2020 Paving Project(s) – Phase II

PROJECT NUMBER: 0916-8216

Heritage Elementary School

ADDENDUM NO. 1

1 PARTIAL SITE PLAN - ELECTRICAL

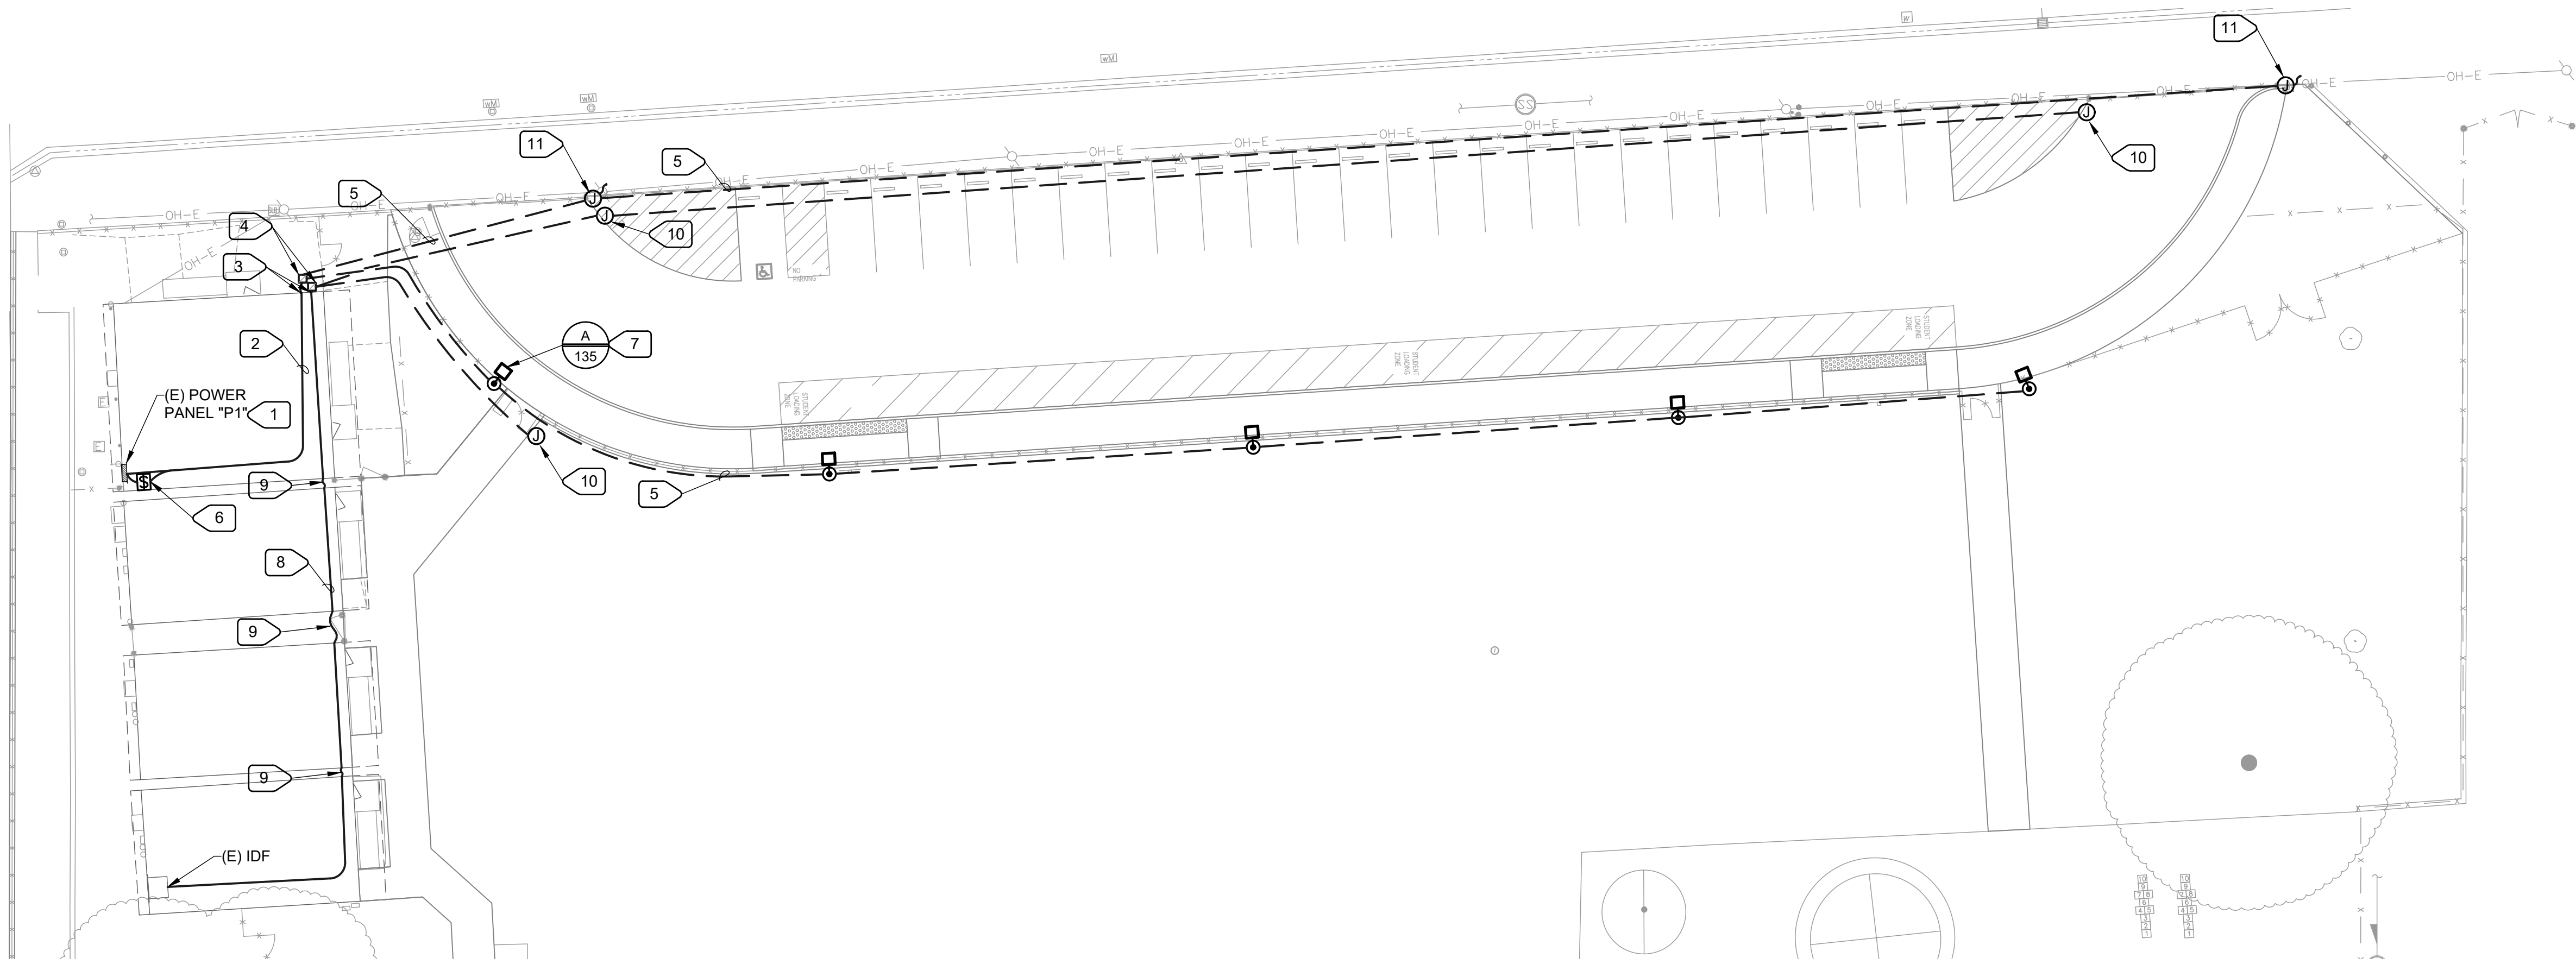
- 1.3 Refer to Drawing Sheet C1.1 Demolition Plan. Replace in its entirety with Drawing Sheet C1.1 Demolition Plan, dated 01/27/2020.
- 1.4 Refer to Drawing Sheet C3.1 Paving Plan. Replace in its entirety with Drawing Sheet C3.1 Paving Plan, dated 01/27/2020.
- 1.5 Insert Drawing Sheet E100 Partial Site Plan – Electrical, dated 01/24/2020.

- 1.8 **Question:** Per specification section 00 11 16-1 provides the general scope of work which notes "lighting..." however it does not appear that there is lighting on the plans. Please advise.

- 1.23 **Question:** Note 16 on sheet C3.1 calls for 2 conduits but is pointing to two different lines. So are there 2 conduits or 4 conduits running to the pull boxes?

Response: Delete all the conduit notes on sheet C3.1. Refer to Drawing Sheet C1.1 Demolition Plan, dated 01/27/2020. Also refer to Drawing Sheet E100 Partial Site Plan – Electrical, dated 01/24/20 for clarification.

Response: Refer to Drawing Sheet E100 Partial Site Plan – Electrical, dated 01/24/20 for clarification.
- 1.24 **Question:** Will we need to phase the demolition and grading of the work to be done closer to the school along the path of travel after students are not in school anymore? Will we need to fence these off if kids are still in school?

4 CONDUIT TRENCHING DETAIL

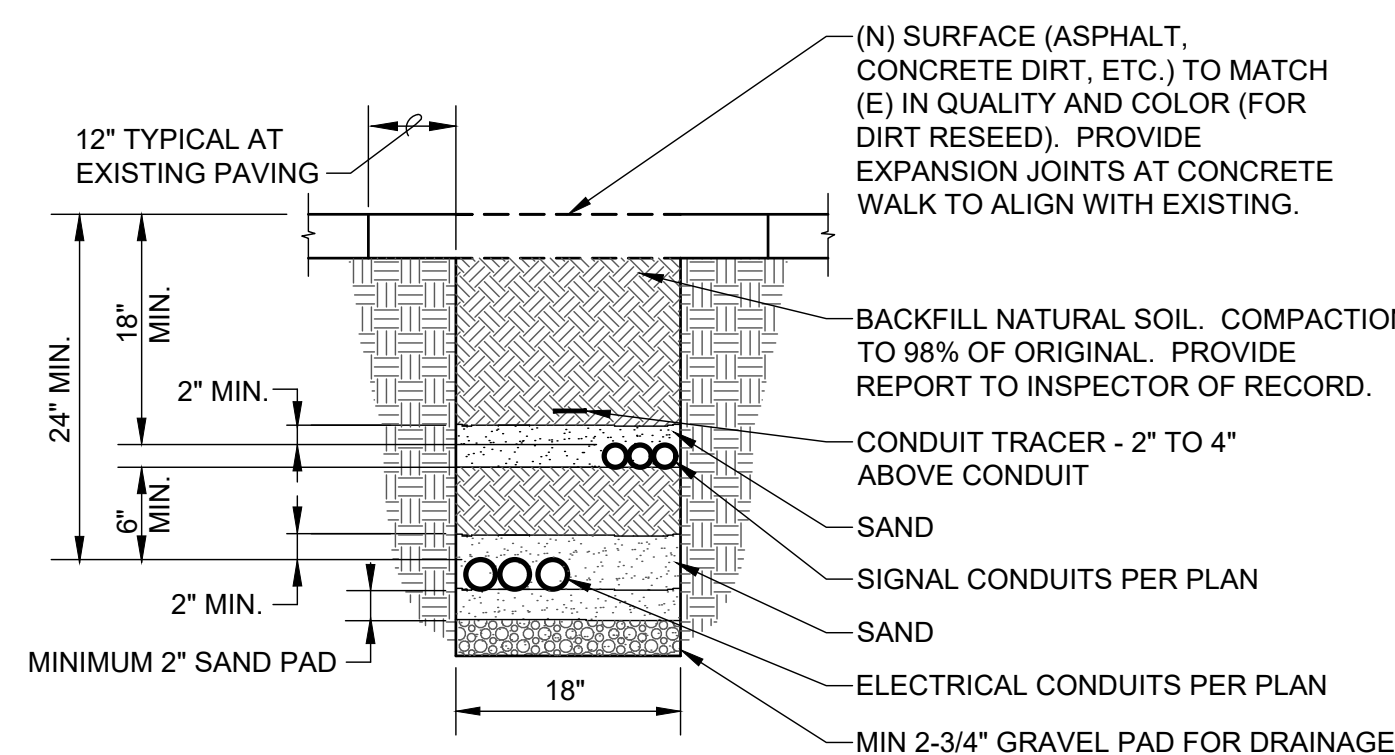
Response: Native material is acceptable.
- 1.20 **Question:** Can we backfill the conduit with native material?
Response: Refer to Drawing Sheet E100 Partial Site Plan – Electrical, dated 01/24/20 for clarification.

- 1.21 **Question:** How deep does the conduit need to be from finish grade?
Response: Refer to Drawing Sheet E100 Partial Site Plan – Electrical, dated 01/24/20 for clarification.
